**BID ADDENDUM NO. 1**

**PROJECT TITLE:** Sneath and Lake Pump Station Rehabilitation Project

**PROJECT NO.** 11003 & 11004

**DATE:** 3/20/2026

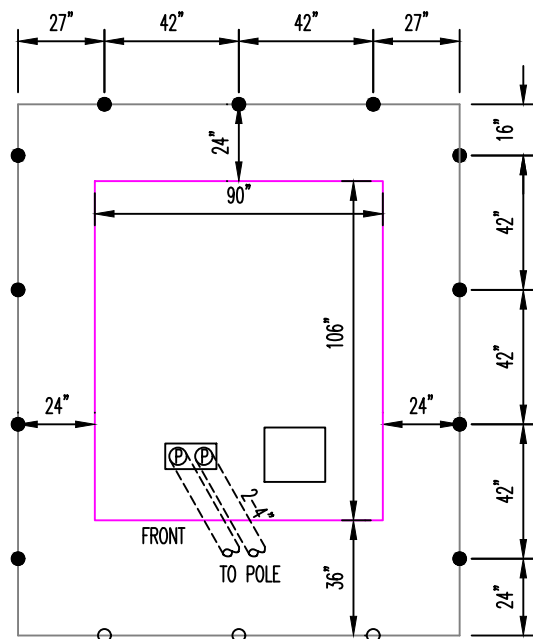
1. Do both pump stations require a bypass?  
*Response: Yes, temporary bypass systems are required at both locations. Please refer to the technical specifications, section 33 31 50.*
2. Is there a new generator proposed at Sneath Pump Station?  
*Response: Yes, please refer to the plans.*
3. Can we stage at the adjacent lot? (Sneath Pump Station)  
*Response: The adjacent lot is private property and would require coordination with the property owner and a Temporary Use Permit (TUP). There is a proposed development project at that location that may go into construction while the Sneath and Lake Pump Station Rehabilitation Project is in construction.*
4. Are the cabinets along Sneath Lane for the pump station? See picture below for reference.

*Response: No, they are for the traffic signal and not part of the pump station.*

**CONSTRUCTION SKETCH**  
OH TO UG SERVICE CONVERSION  
S/END OF LAKE DR, SAN BRUNO

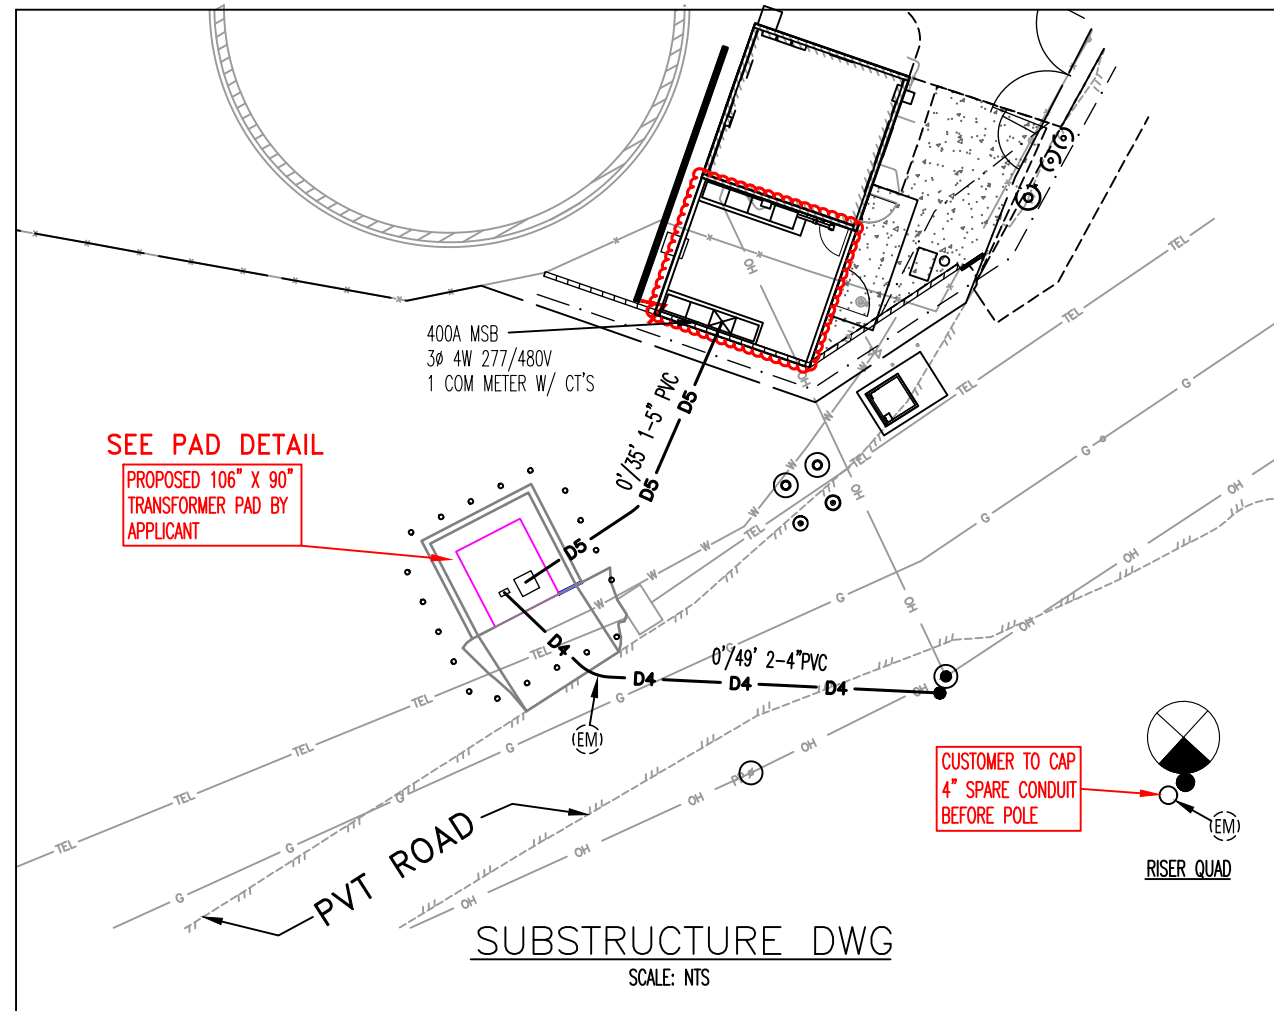
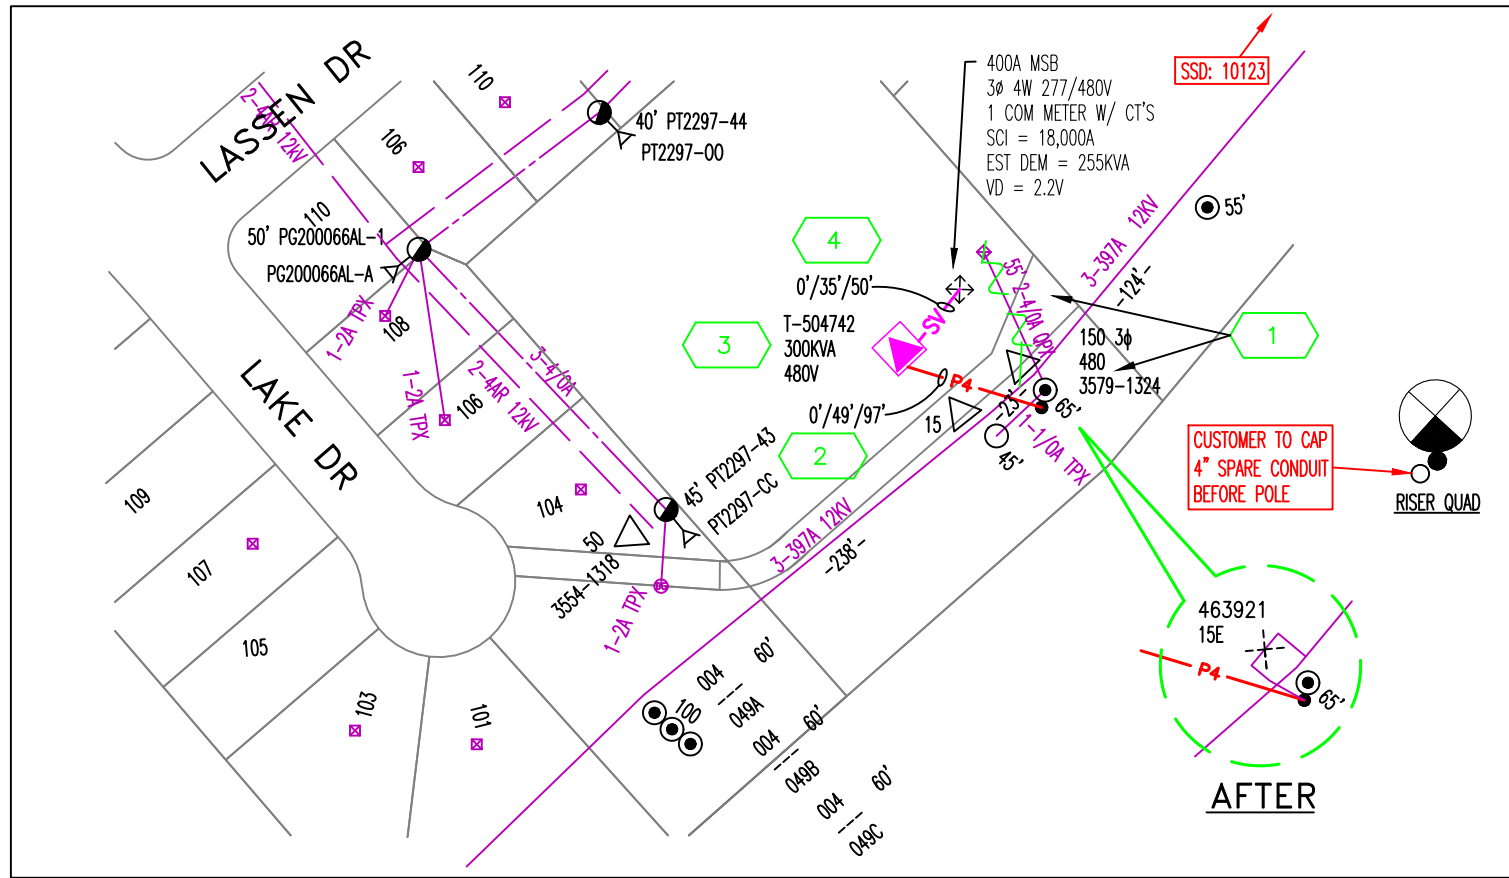
1. THE CITY OF SAN BRUNO'S WATER PUMP STATION WILL REPLACE THE EXISTING 400A, 3PH, 277/480V MSB WITH AN IDENTICAL UNIT. THE SERVICE WILL BE CONVERTED TO UNDERGROUND FROM A NEW PM-TRANSFORMER. THE CUSTOMER IS PROVIDING SPACE FOR THE TRANSFORMER AND WILL INSTALL NEW CONDUITS AND SUBSTRUCTURE. FULL COST TO CUSTOMER.
2. APPLICANT WILL TRENCH & INSTALL ALL NEW CONDUITS AND SUBSTRUCTURES, BACKFILL AND PAVE.
3. APPLICANT TO INSTALL ELECTRONIC MINI-MARKER SYSTEM AT END & BENDS OF SPARE/ EMPTY CONDUIT AT LOC. 2.
4. PLC IS NOT REQUIRED, AS THERE IS NO ADDITIONAL LOAD ON THE POLE.

- REMOVE 150KVA 3φ OH TRANSFORMER BY PG&E
- REMOVE OH SERVICE CABLES BY PG&E
- REMOVE 400A METER BY PG&E. APPLICANT TO REMOVE OLD MAIN PANEL
- INSTALL NEW 2-4" PVC CONDUITS BY APPLICANT
- INSTALL NEW 1-5" PVC CONDUIT BY APPLICANT
- INSTALL NEW 3-1/0 AL EPR-CONC-ENCAP 25KV UG PRIMARY CABLES IN NEW 1-4" CONDUIT. 2ND CONDUIT IS SPARE
- INSTALL NEW 1-750 AL QPX SERVICE CABLES BY PG&E IN NEW 1-5" PVC CONDUIT
- NEW 400A METER W/ CT'S BY PG&E. APPLICANT TO INSTALL THE 400A, 3φ 277/480V MAIN SWITCH BOARD
- NEW ELECTRONIC MINI MARKER SYSTEM BY APPLICANT (M374947)
- INSTALL NEW PART-63H CUTOUTS BY PG&E
- INSTALL NEW 106" X 90" STYLE II-E TRANSFORMER PAD (M040292) BY APPLICANT
- INSTALL NEW 300KVA 3φ 277/480V 12KV STYLE II-E LB PADMOUNTED TRANSFORMER BY PG&E
